Staff Report

Report To: Council Meeting
Meeting Date: October 13, 2026
Report Number: ADM.26.071
Title: Response to Bay Street Notice of Motion
Prepared by: Adam Smith, Chief Administrative Officer

RECONSTRUCTION OF BAY ST EAST
GREY ST NORTH AND GREY ST SOUTH

1. Attachment 1 – Option 2 Sidewalk Design

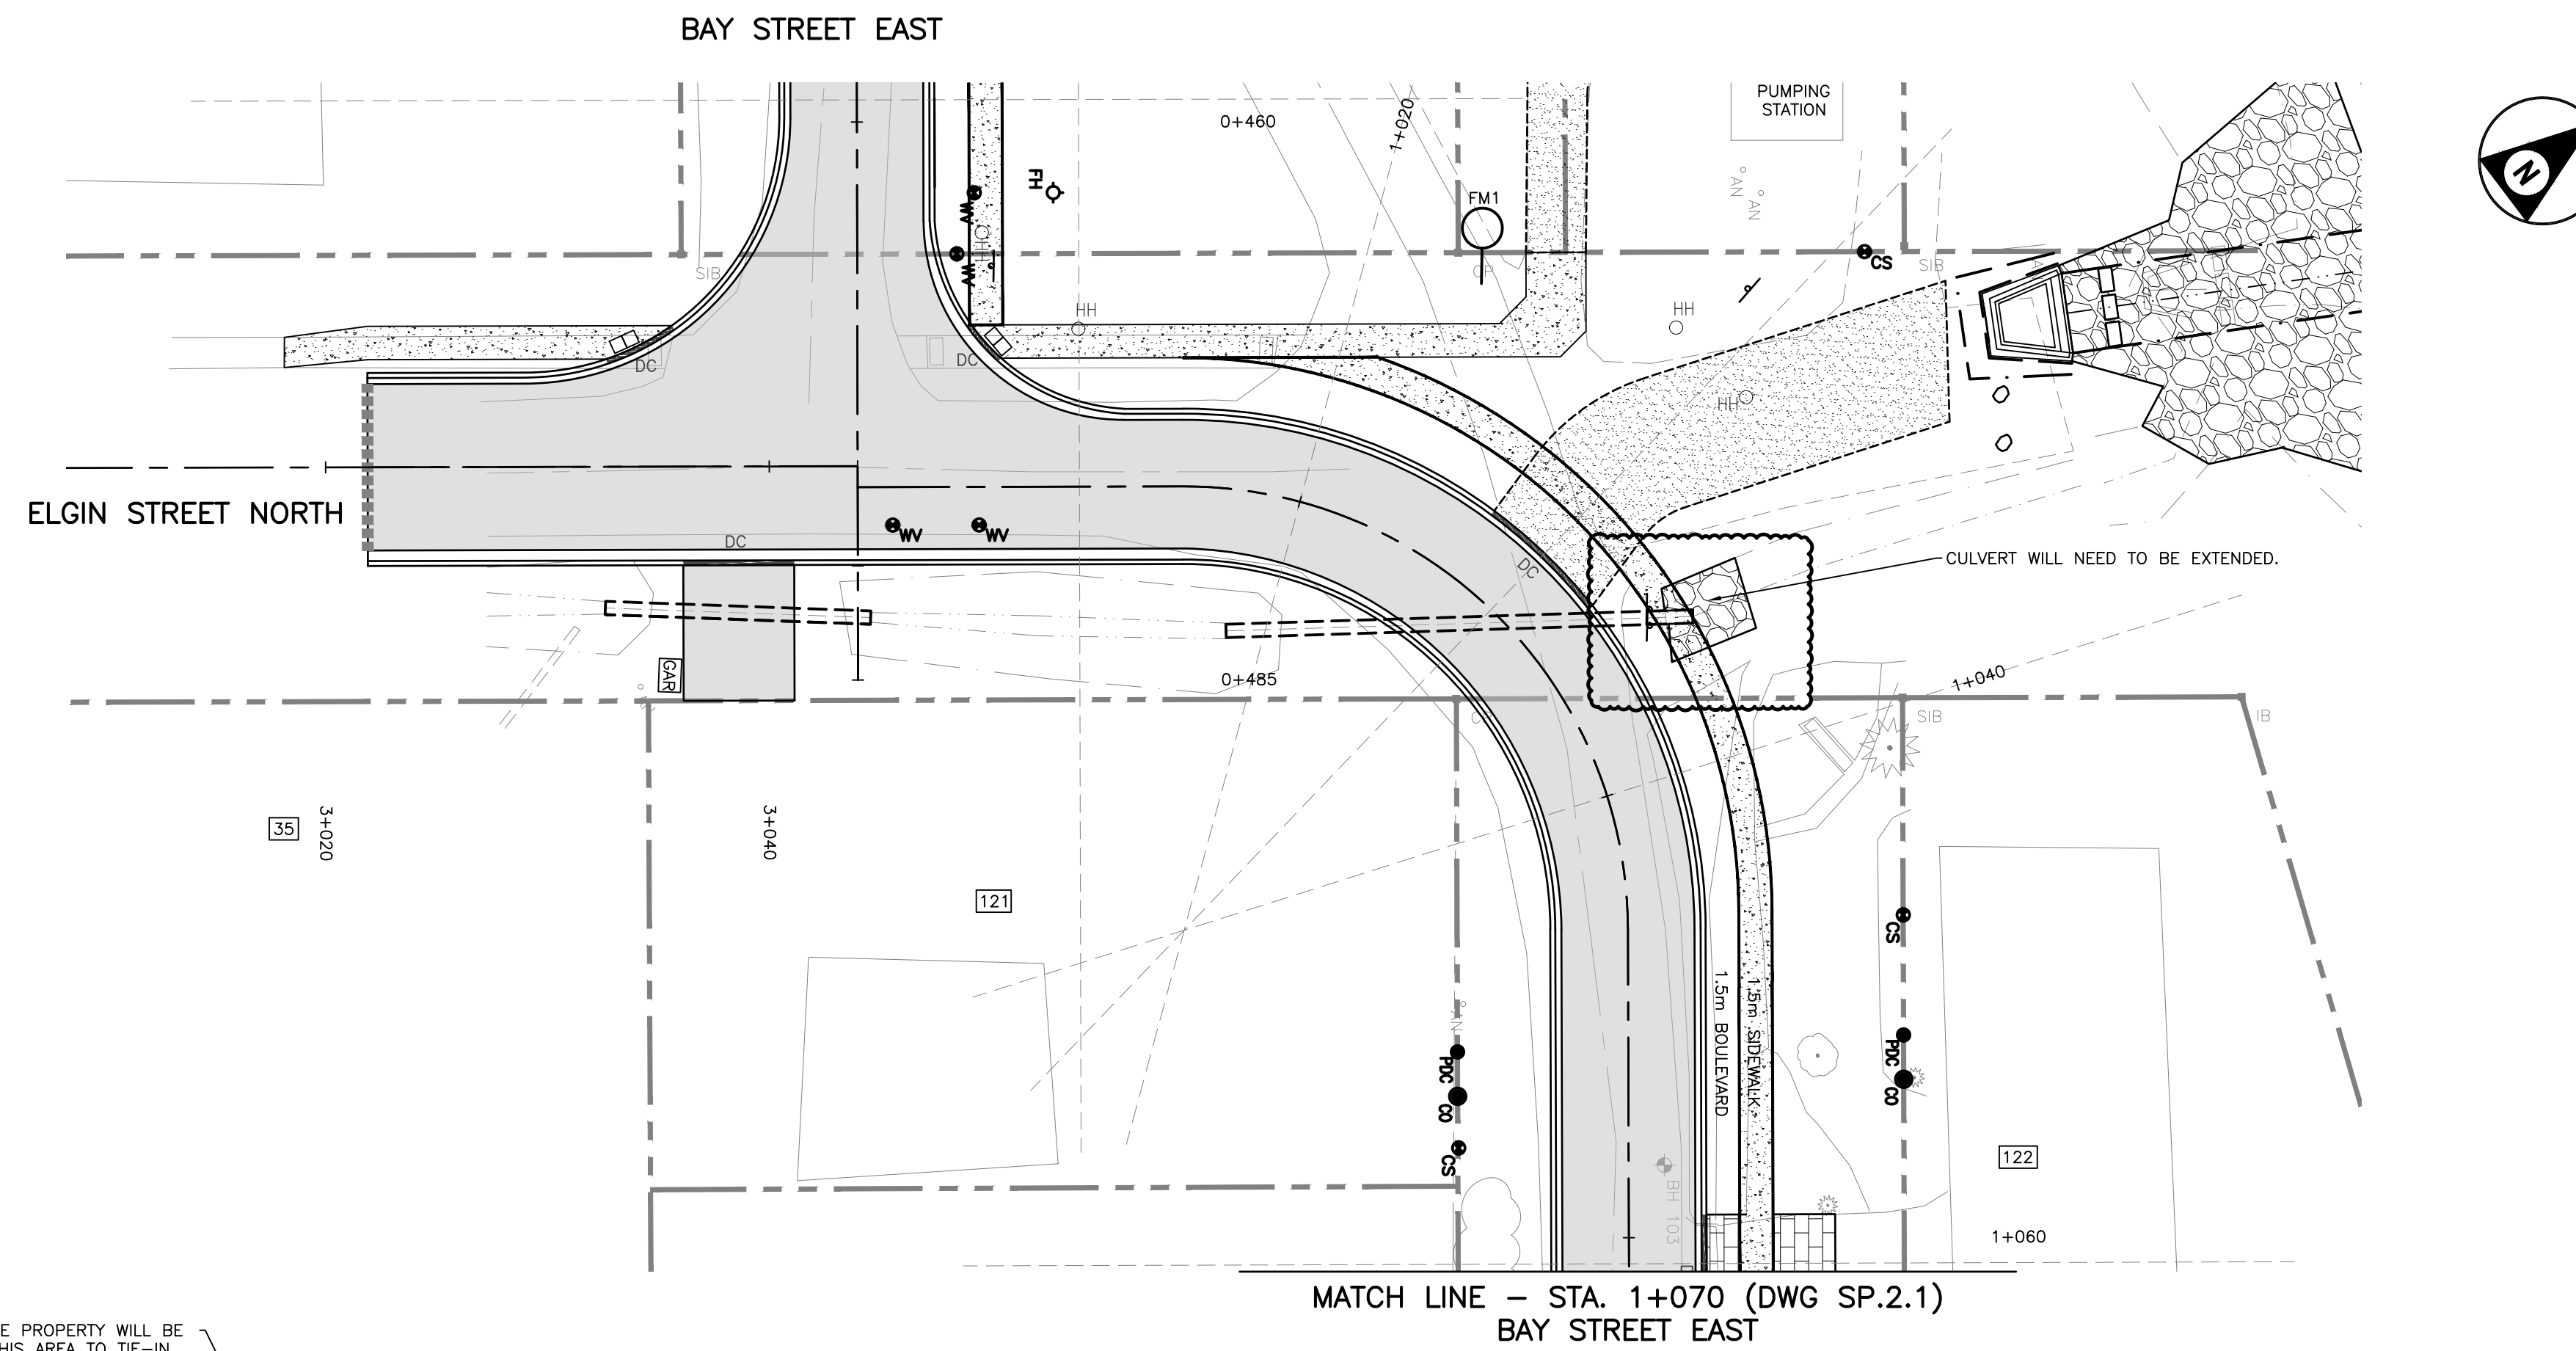
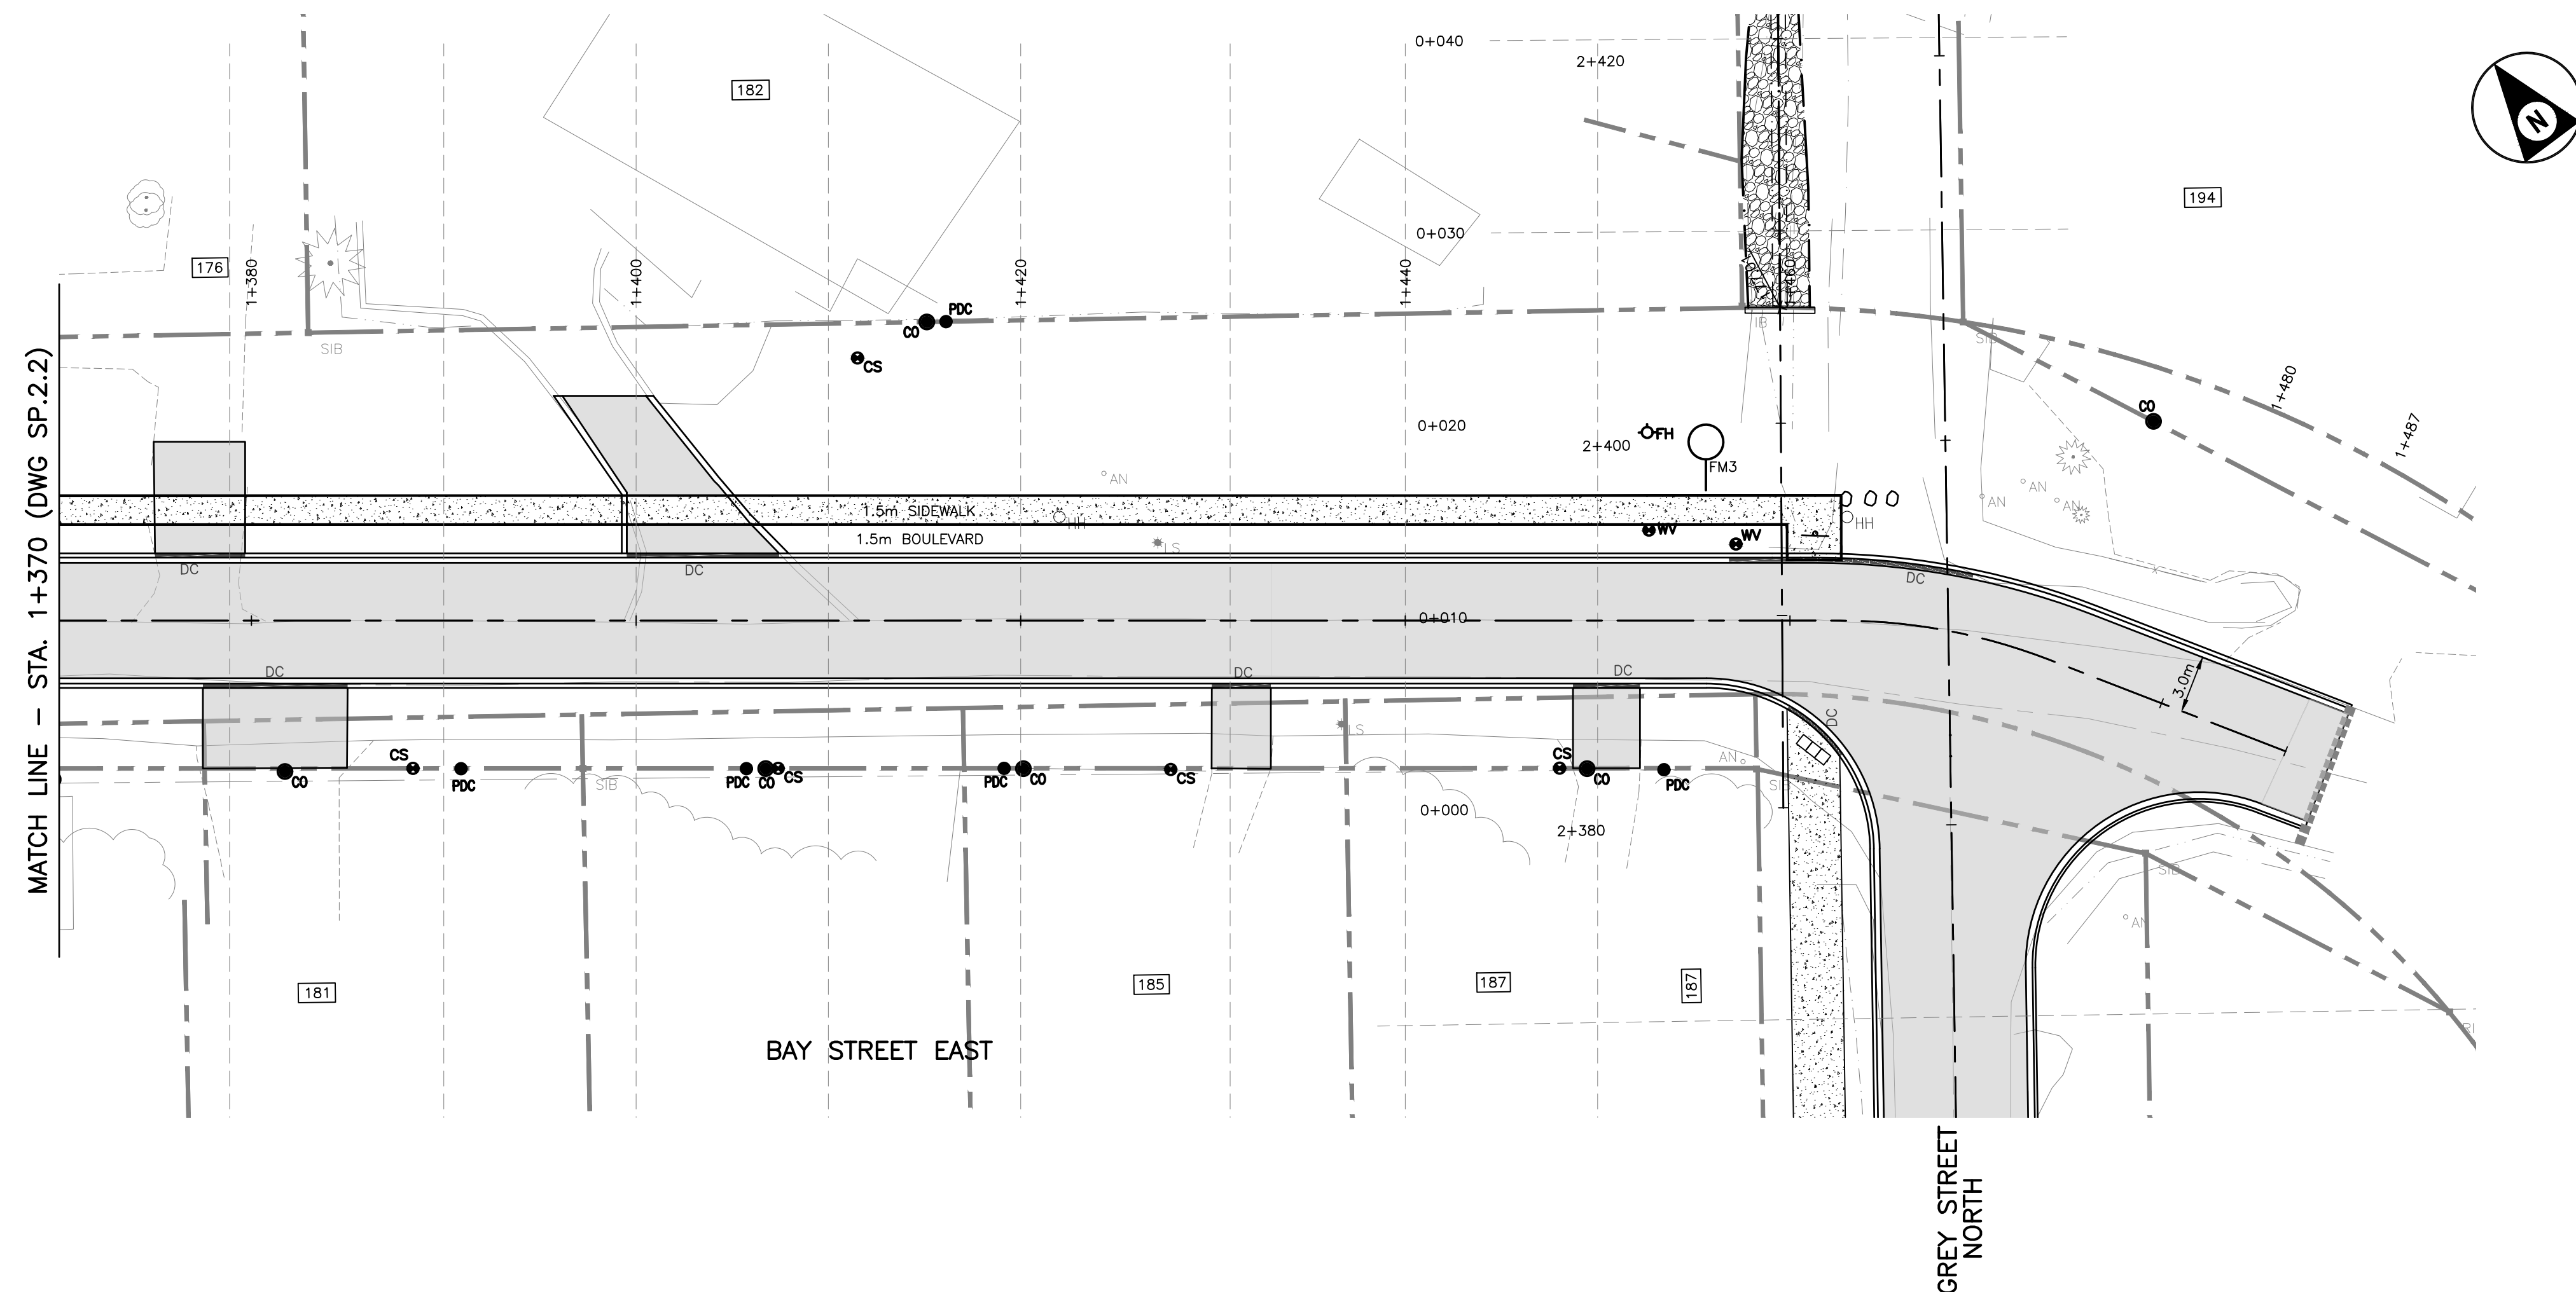
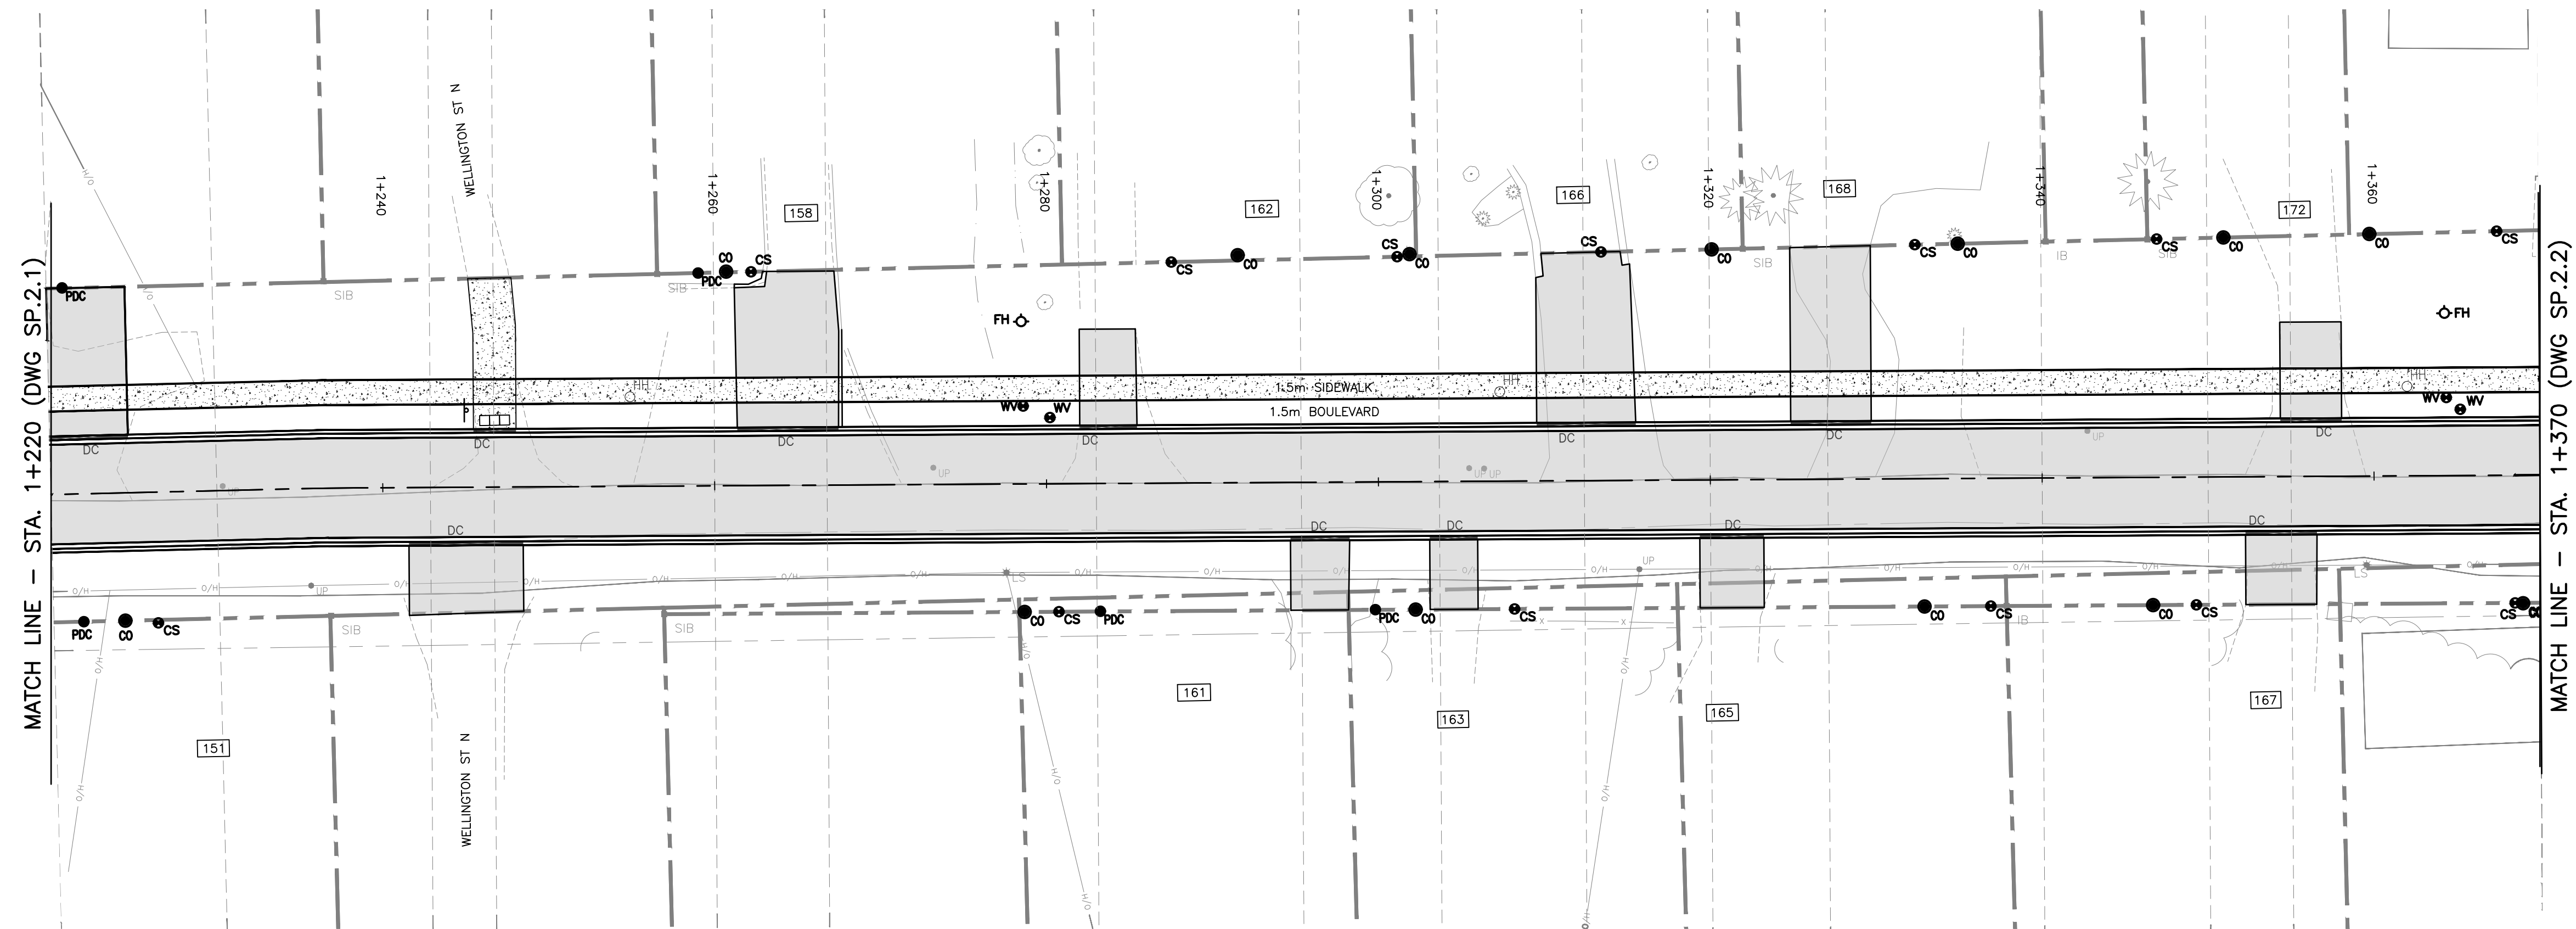
fundamentally unsafe and inconsistent with accessibility. As such, in order to achieve this objective a minimum 1.5 m wide sidewalk would be required on the north side of the road from Grey St. to Mill St.

Option #2: Direct a scope change in supporting the reconsideration to include a 1.5 metre sidewalk between Grey Street and Mill Street.

If this occurs, staff will need to proceed with an immediate scope change to ensure the sidewalk can be constructed within the construction window and avoid additional contract management costs associated with these works extending into summer 2027. The sidewalk will also cost an additional \$300K which can be taken from the project's contingency budget but constrains the ability to respond to future unforeseen risks that may arise through the remainder of the project timeline. Attachment #1 provides a concept of the sidewalk design to be constructed.
